Access Compliance Report

Public Rights-of-Way

(Island Curb Cuts)

Intersection ID: 15477	Main Street: W_TYVOLA_RD	Cross Street: CASCADE_POINTE_BV	Location: W
ADA ID: C1C3BB116660	Curb Cut Type: IslandRefuge3	Initial Pass/Fail: Fail	Overall Compliance: No
Severity Score: 36.25			
Codes/Mitigation Info/Possible Solution		Field Measurements/Component Compliance

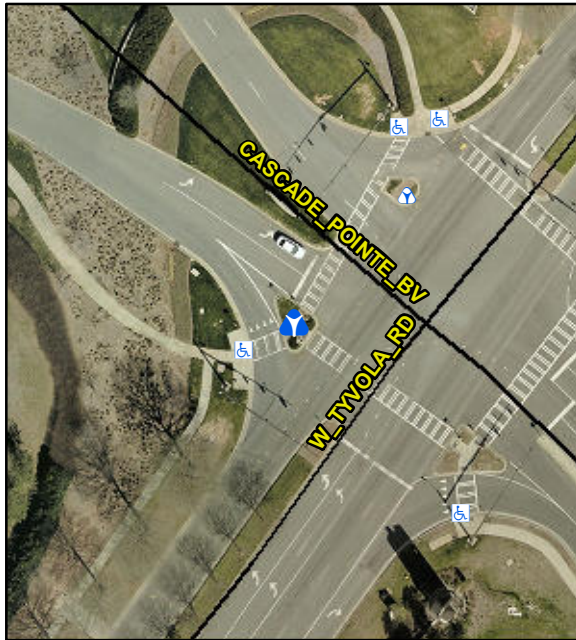
Compliance	Description	Data	Compliance	Description	Data
Yes	Refuge 1 Length (In)	92.0	N/A	Gutter 1 Ponding?	N/A
No	Refuge 1 Width (In)	59.0	N/A	Gutter 1 Lip Ht (In)	N/A
Yes	Refuge 1 Slope (%)	0.9	N/A	Gutter 1 Slope (%)	N/A
Yes	Refuge 1 X Slope (%)	4.1	N/A	Gutter 1 X Slope (%)	N/A
N/A	Painted X Walk1?	Yes	N/A	DWS 1 Provided?	N/A
N/A	X Walk 1 Direction	To NE	N/A	DWS 1 Contrast?	N/A
N/A	X Walk 1 Width (In)	83.0	N/A	DWS 1 Length (In)	N/A
N/A	Road 1 Slope (%)	3.0	N/A	DWS 1 Full Width?	N/A
N/A	Road 1 X Slope (%)	4.1	N/A	DWS 1 Offset (In)	N/A
Yes	Refuge 2 Length (In)	92.0	N/A	Gutter 2 Ponding?	N/A
No	Refuge 2 Width (In)	59.0	N/A	Gutter 2 Lip Ht (In)	N/A
Yes	Refuge 2 Slope (%)	2.3	N/A	Gutter 2 Slope (%)	N/A
Yes	Refuge 2 X Slope (%)	3.0	N/A	Gutter 2 X Slope (%)	N/A
N/A	Painted X Walk2?	Yes	N/A	DWS 2 Provided?	N/A
N/A	X Walk 2 Direction	To SW	N/A	DWS 2 Contrast?	N/A
N/A	X Walk 2 Width (In)	108.0	N/A	DWS 2 Length (In)	N/A

N/A	Road 2 Slope (%)	5.8	N/A	DWS 2 Full Width?	N/A
N/A	Road 2 X Slope (%)	1.2	N/A	DWS 2 Offset (In)	N/A
Yes	Refuge 3 Length (in)	83.0	N/A	Gutter 3 Ponding?	N/A
No	Refuge 3 Width (in)	58.0	N/A	Gutter 3 Lip Ht (in)	N/A
Yes	Refuge 3 Slope (%)	1.5	N/A	Gutter 3 Slope (%)	N/A
Yes	Refuge 3 XSlope (%)	1.4	N/A	Gutter 3 XSlope (%)	N/A
N/A	Painted X Walk3?	Yes	N/A	DWS 3 Provided?	N/A
N/A	X Walk 3 Direction	To SE	N/A	DWS 3 Contrast?	N/A
N/A	X Walk 3 Width (in)	112.0	N/A	DWS 3 Length (in)	N/A
N/A	Road 3 Slope (%)	2.5	N/A	DWS 3 Full Width?	N/A
N/A	Road 3 XSlope (%)	3.	N/A	DWS 3 Offset (in)	N/A
Yes	Any Obstructions?	N/A	N/A	Storm Grate/Utility Hazard?	N/A
N/A	Obstruction Type		N/A	Storm Grate/Utility Type	
N/A	Surface Condition	Good	N/A		N/A

Remove & Replace Entire Refuge.
